CITY OF BUELLTON

Subject: Conceptual Review of Proposed Drive-thru Lanes
234 East Highway 246

RE: JM Holliday Associates Site Plan Study 2-Drive Up Aisles – Dated April 24, 2012
Traffic – Parking Circulation Comments

Site Plan Study
Drive Up Aisles

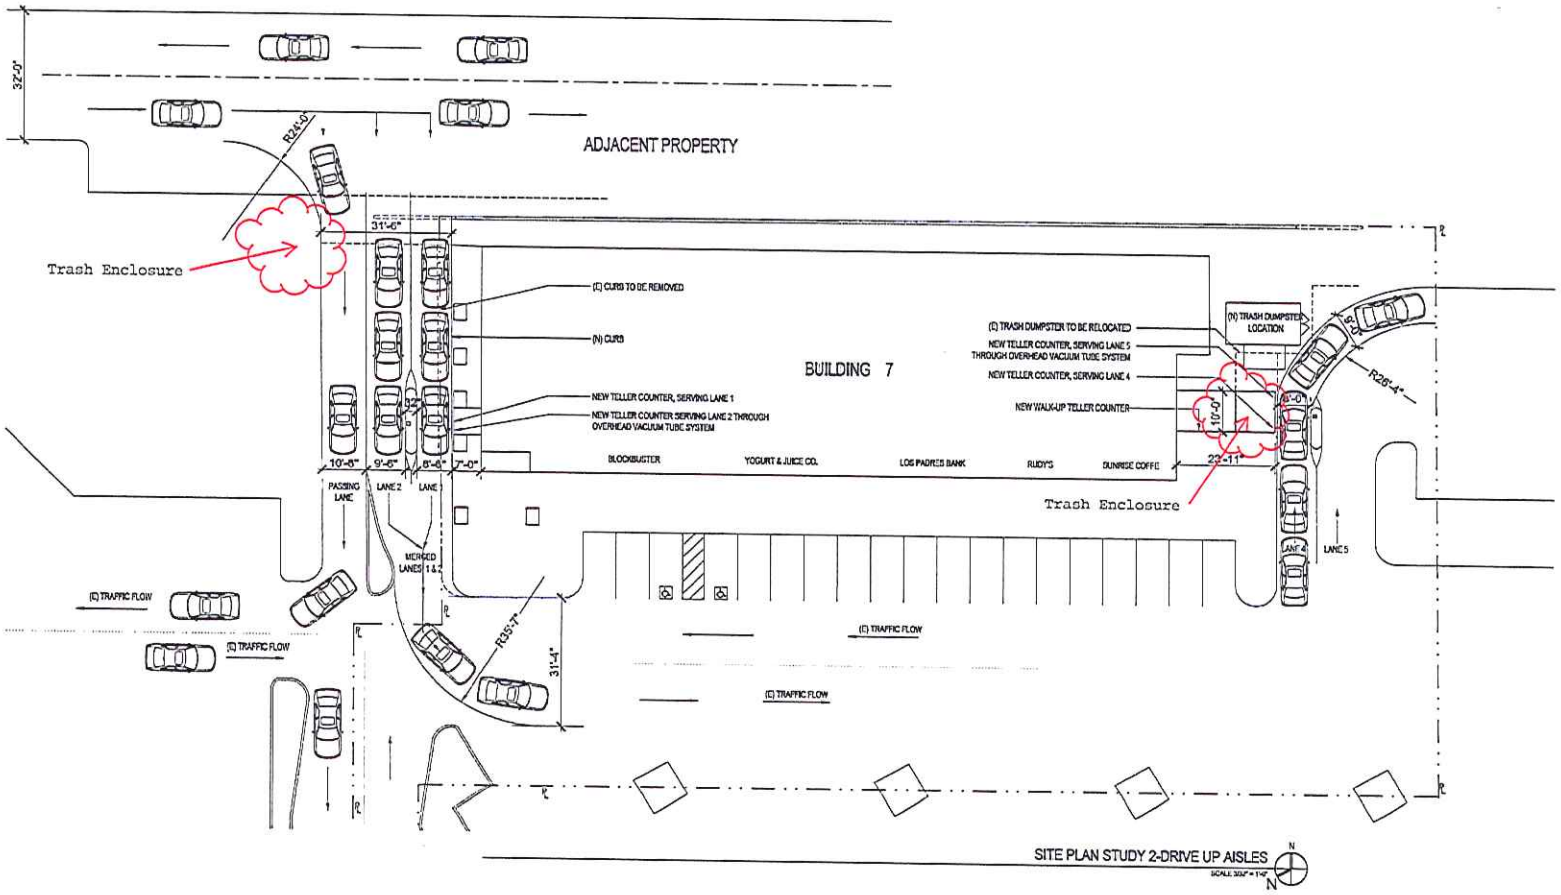
- The relocated trash enclosure is still blocked by the drive-thru lane.
- Not enough stacking is provided and vehicles will queue into the drive aisle and create traffic hazards and possible ADA impediments.
- The right turn exiting of lanes 4 and 5 are in direct conflict with the two-way parking lot traffic.

1. A Vehicle Stacking Analysis is required for "Drive Up" Aisles (North and South locations of Building 7) for the proposed drive-thru teller facilities. The current aisle configuration cannot be determined feasible without this supporting documentation. Both locations have the potential to "bottle neck" the parking circulation, affecting the surrounding existing businesses. The analysis should include future anticipated peak hours, generally Mid-day and PM Peak as a minimum. The result of the Vehicle Stacking Analysis may not impede on- or off-site traffic movements or movements adjacent to parking spaces. Stacking spaces must be a minimum of 8′ by 20′ in size. If ADA crosswalks are to be maintained thru proposed Aisles, this space shall be reserved and not an included in the allowable Vehicle Stacking area.

2. The current configuration of the trash dumpsters (2 Total) are in direct conflict with proposed improvements and will need to be revised. The first trash dumpster, at the exit to Lane 4 (South), is to be relocated East, but still in conflict with exiting vehicles. While relocation of the trash dumpster is limited, additional supporting documentation should be provided for planned/maintained safe operation for all the current businesses that use this dumpster.

4. Verify and label all new and existing curbing, striping, pavement markings, and signage within the project limits.

5. General dimensions as shown should be verified as the 31′-6″ is approximately 31′-4″ at the 10′-8″ / 9′-6″ / 32″ / 8′-6″. Please label all change in dimensioning for lane widths/curb alignment.

6. Label all existing ADA access ramps to remain/remove/ or modified as required within the project limits. Access to existing ADA sidewalk pathways need to be maintained, specifically through all proposed "Drive Up" Aisles.

7. Label all existing parking stalls to remain/remove/or modified within the project limits (specifically the impacts to the East Adjacent Property).
8. The intersection adjacent to the exit of the Northern "Drive Up" Aisle has non-standard opposing vehicular traffic that will make it difficult to navigate. Due to the single-lane nature of parking facilities, it is required that additional traffic control devices support the proposed layout. Please revise or provide improvements to the intersection, refer to the California Manual on Uniform Traffic Control Devices (CA-MUTCD) for pavement markings and signage for restricted turning movements.

9. According to *The Dimensions of Parking, 5th Edition*, it is recommended that entrances to parking teller stations begin at 13-16 feet in width and taper down to 10 feet. While this doesn't directly apply to the bank teller, it is recommended that a larger width for Lane 4 be considered for extra mobility and safety with larger vehicles. Please provide supporting documentation for 8'-0" Aisles are adequate for this location.

10. The right turn movement exiting Lanes 4 & 5 are conflicting with the current two-way parking lot traffic. The current layout is not adequate and additional considerations should be made to parking circulation.

11. It is understood that there are additional impacts not shown or labeled to the Adjacent Property to the East, as they are shown outside of the existing property line limits. Please include full limits of improvements to be shown on the Site Plan Study Drive Up Aisle Plans.
